**PROPOSED CHANGE NO. 16**

**Date:** November 29, 2023  
**File:** 8.1C-01.4.03  
**Project No.:** 2005  
**Project:** Burlington Central HS Renovation  
**Trade Contract:** General Contractor

**Description: Site Upgrades**

**1 KEY SITE PLAN**  
A100 1:1000

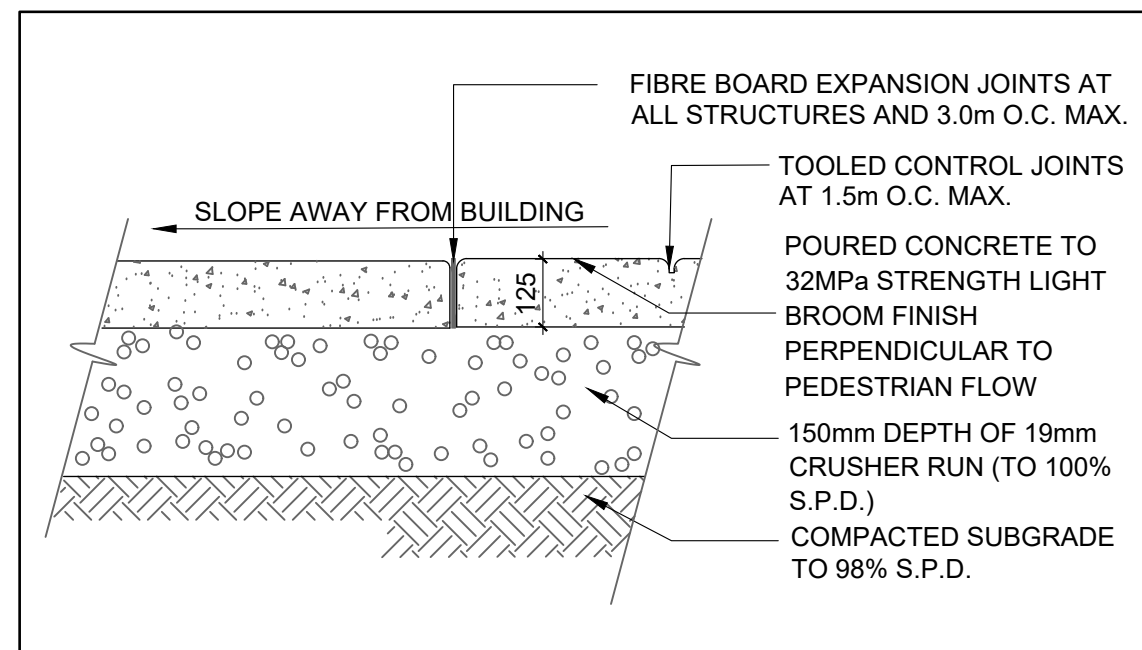
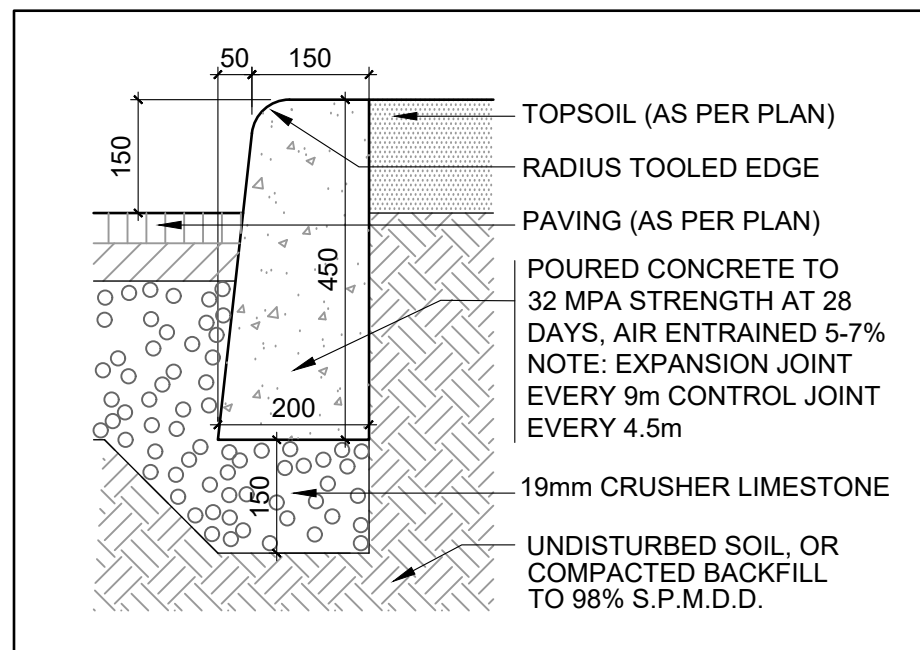
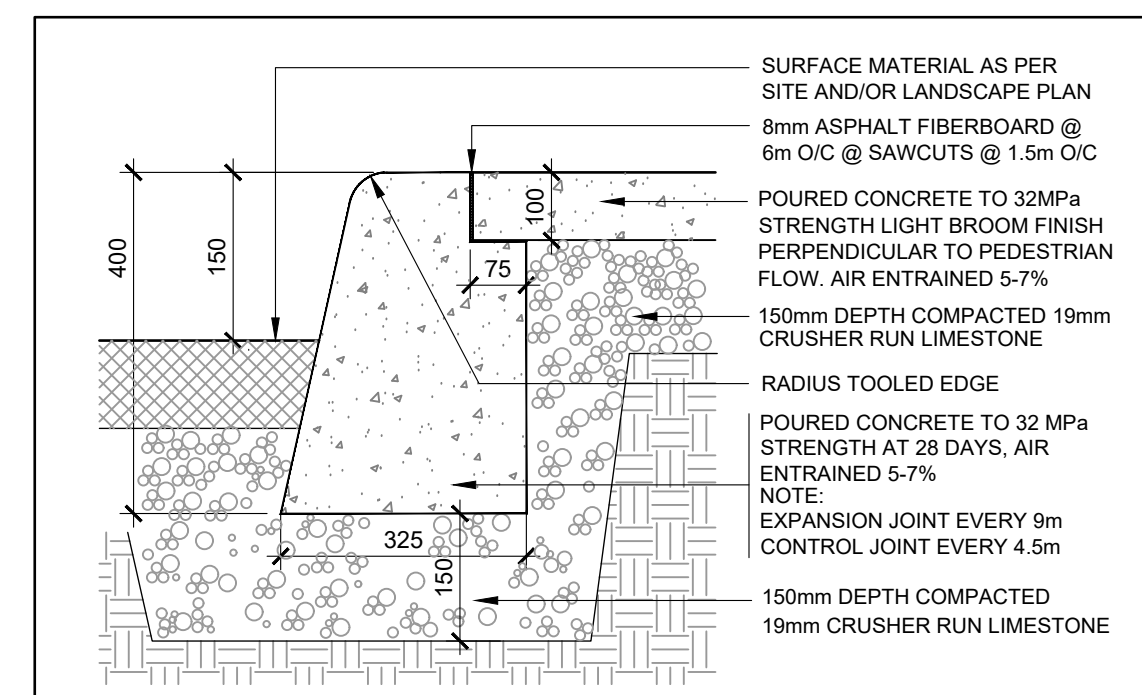
Refer to enclosed A100 Site Plan and A101 Site Plan Enlargement Speed Humps for work which includes;

- Removal of existing sidewalk, curb and railing along the east driveway
- Removal of existing tree stump in the parking lot area
- Removal of existing planter and some lawn areas
- Removal and relocation of 9 armour stones
- Provision of new concrete sidewalk, concrete bike rack pad, and concrete island for garbage bins
- Provision of new concrete curb and repair of existing asphalt driveway and speed humps affected by new work
- Provision of new stainless steel railing along the existing east driveway
- Provision of new asphalt pavement and new painted lines over removed tree stump area
- Provision of soiled area for new butterfly garden (NIC)
- Provision of new speed humps on the existing west driveway
